INDESIT company

Model type:
RAA24SEU

Commercial code:
F058564

51420a0 Exploded views

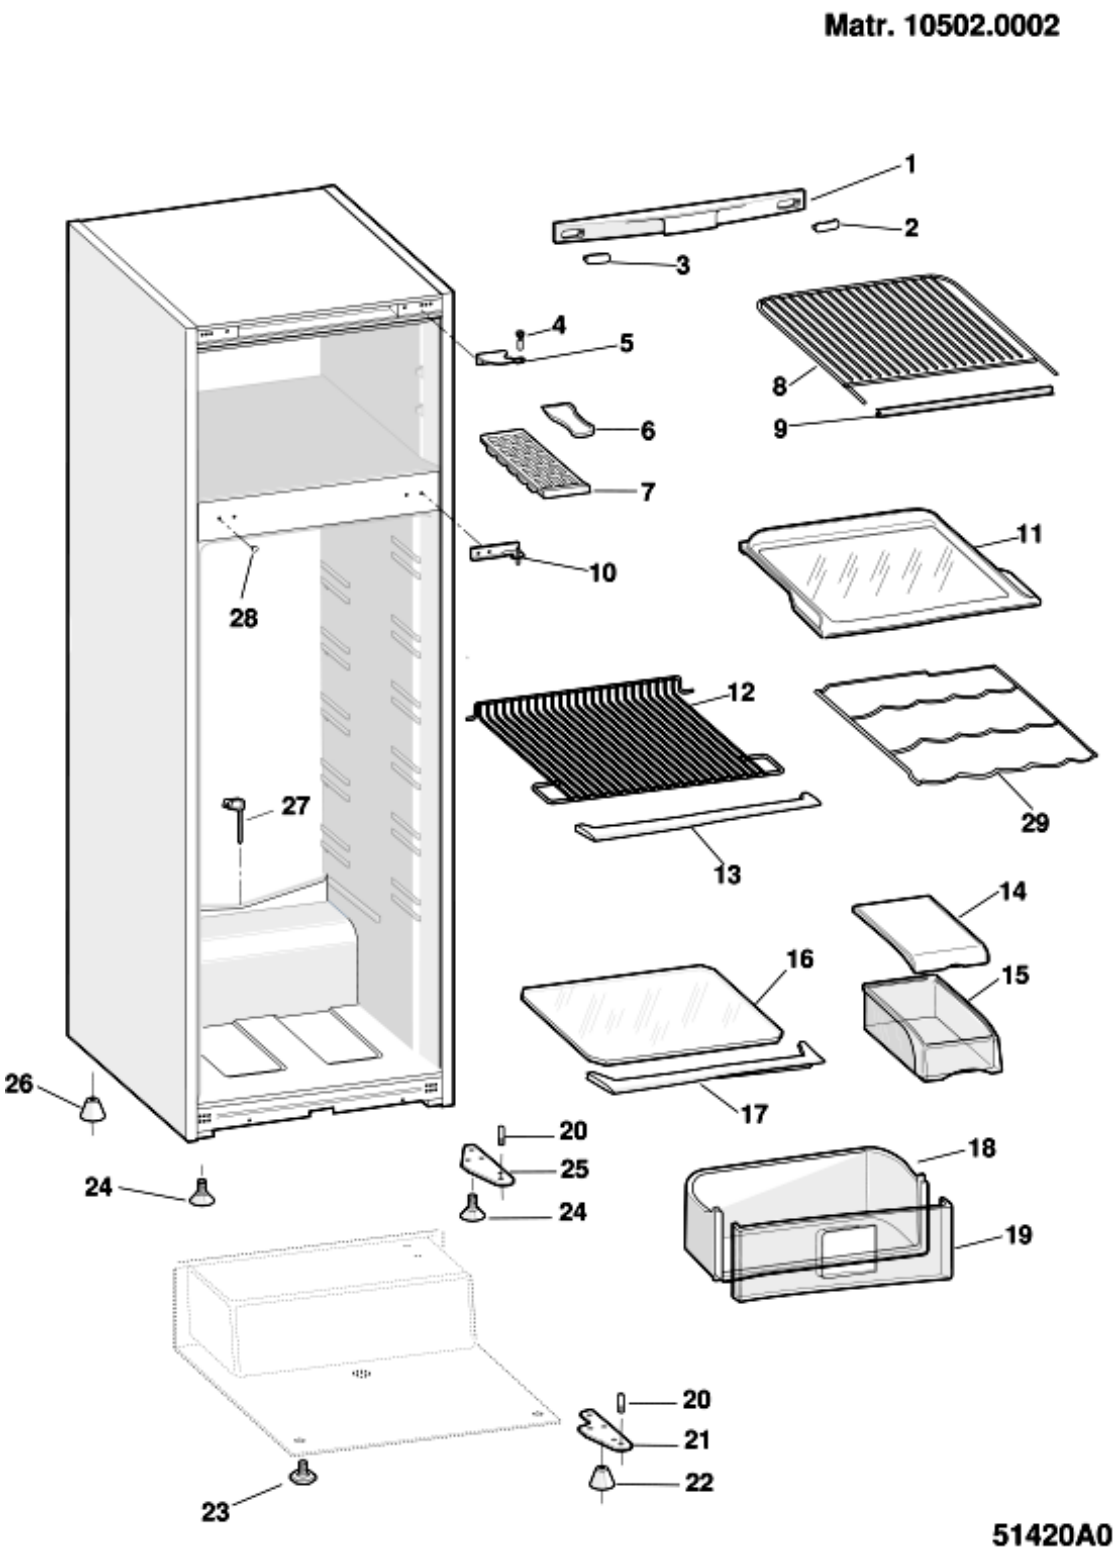
n2510i00: ADJUSTABLE FOOT CHANGED

Dimensions of the foot and its hole for fixing screw are changed to improve sytability of the product.

51421h0 Exploded views

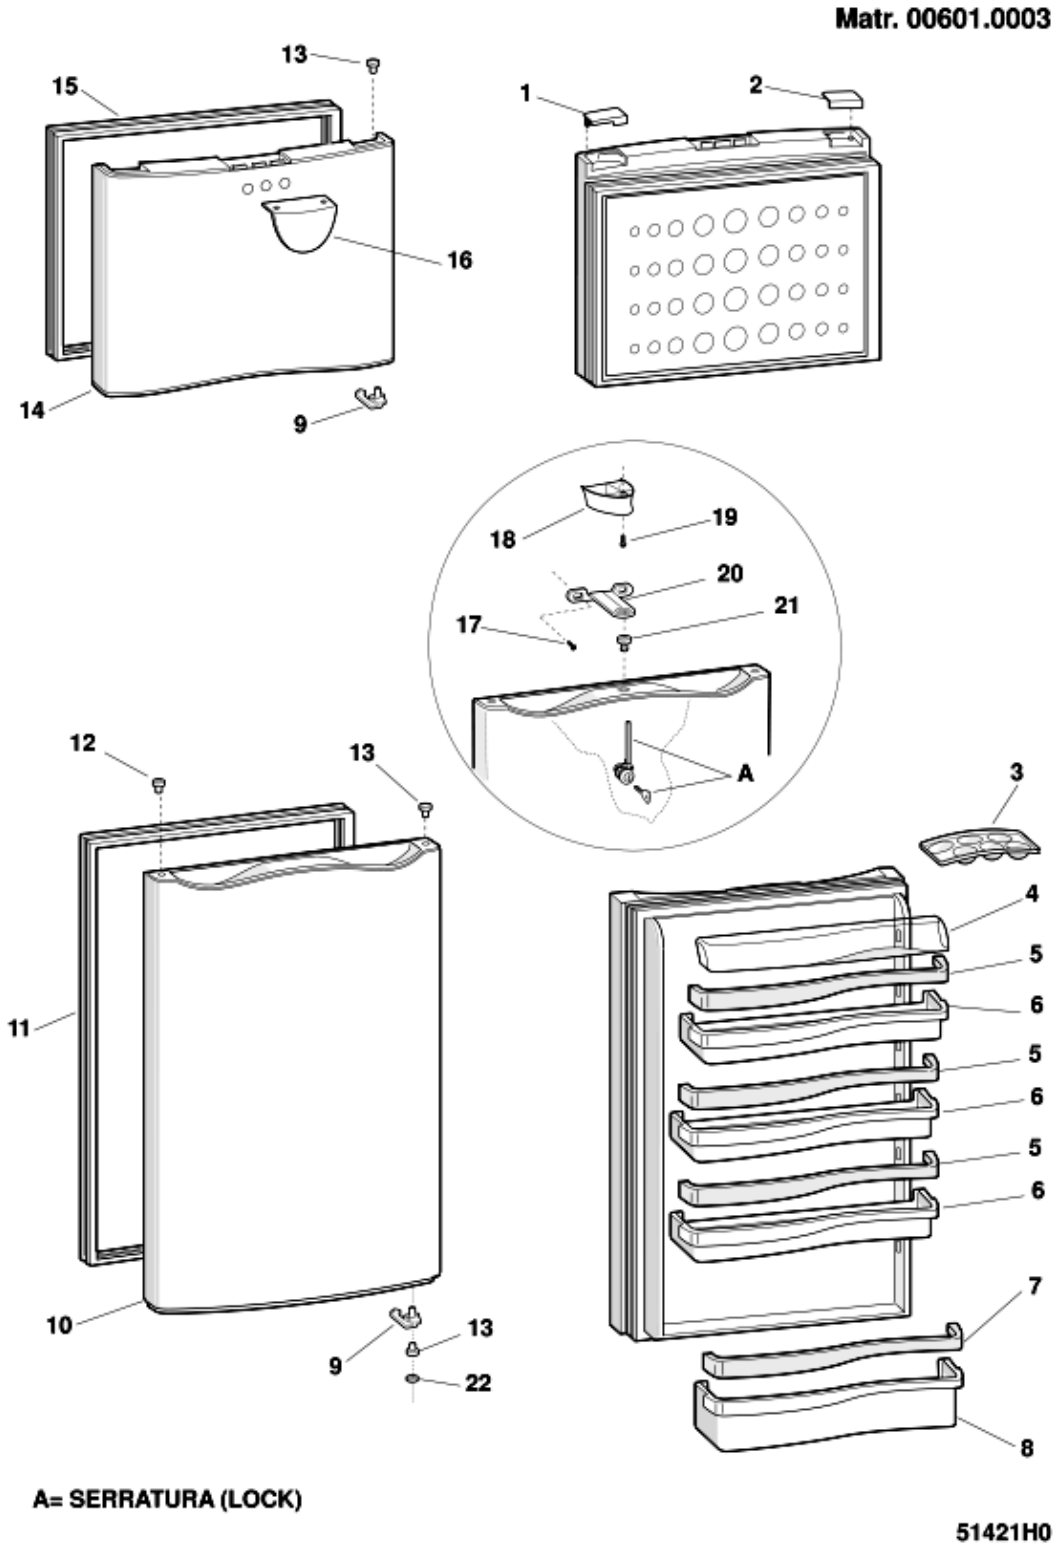
n2511d00: CHANGED COLOR OF EGG HOLDER

n2511e03: DOOR COLOR CHANGED

From 07th March 2011 fridge and freezer doors have changed color.
When existing stocks are used the only color that will be available will be new version: this means that, to make assistance on pre-modification products, will be necessary to order both doors C00285422-C00285423.

5142220 Exploded views

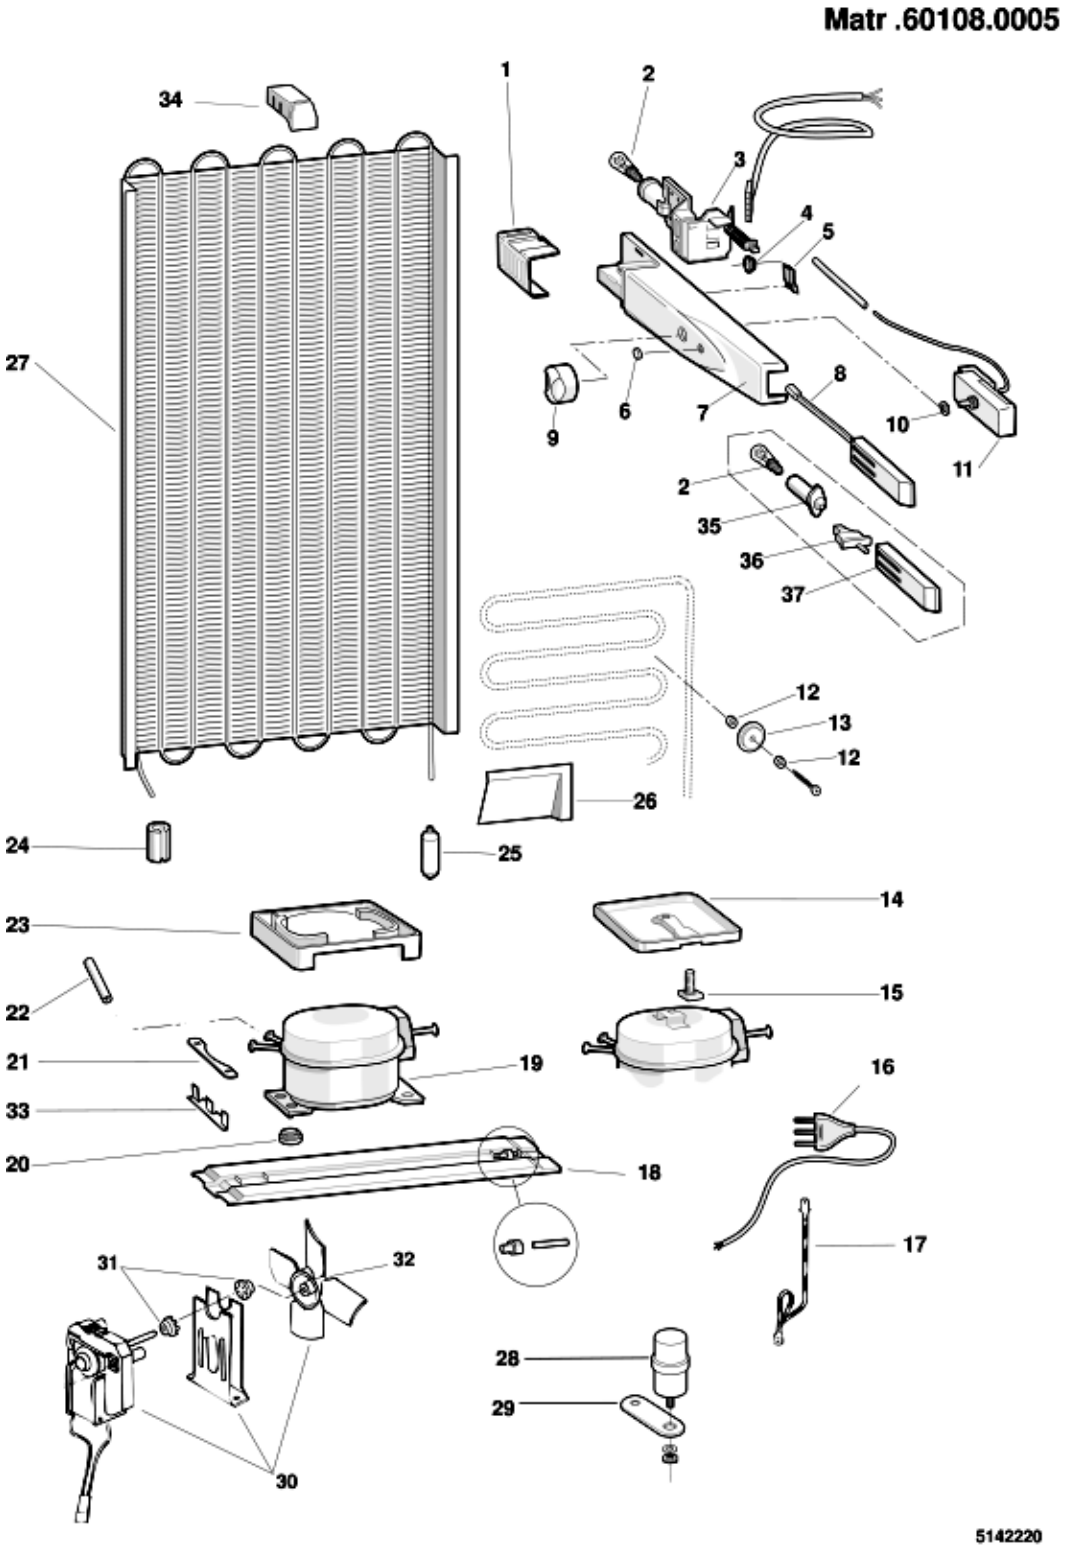
n1025065: Giugiaro-Vossloh thermostat box kit (low Ambient Temp. +16?C)

As of February-2001 (serial no. 10201.0001), the "thermostat box KIT for low ambient temperatures" is being handled with part number 076283 and is to be used on Indesit brand double-door refrigerators that have the Giugiaro thermostat box fitted on them (048503 - 066297).
The kit should be used exclusively to solve those problems obtained due to the poor performance of the freezer due to an ambient temperature below +16°C.
The kit is innovative, as it has a 6.6 Watt resistance fitted inside the thermostat box that should be activated by the toggle switch with a rubber protection situated underneath the thermostat knob. The switch is activated when the ambient temperature drops below +13°C (contacts closed. See the wiring diagram included in the kit).
This resistance heats up and enables the thermostat to be reactivated, thereby allowing the appliance to operate correctly.
On the thermostat box, the resistance is glued onto an aluminium plate (152x42) itself glued to the box.

When replacing the thermostat box, no components should be re-used, and this includes the wiring.
The wiring in the kit has terminals with fastons for connecting them to the compressor's terminal board; in the event of different solutions, then make the suitable adjustments as necessary.
Moreover, the thermostat box in the kit was obtained from the Giugiaro one (066229) with the Vossloh lamp holder and the Eltek switch. On this box, the position of the fixing hole was moved 15 mm up; therefore, on the models that are fitted with the Giugiaro thermostat box (048503), the hole on the cabinet should be remade before mounting the kit.
Moreover, on the models that use the hidden bulb thermostats, the position of the mark should be remade on the thermostat in the kit and, if necessary, the sheath protecting the bulb should be removed.
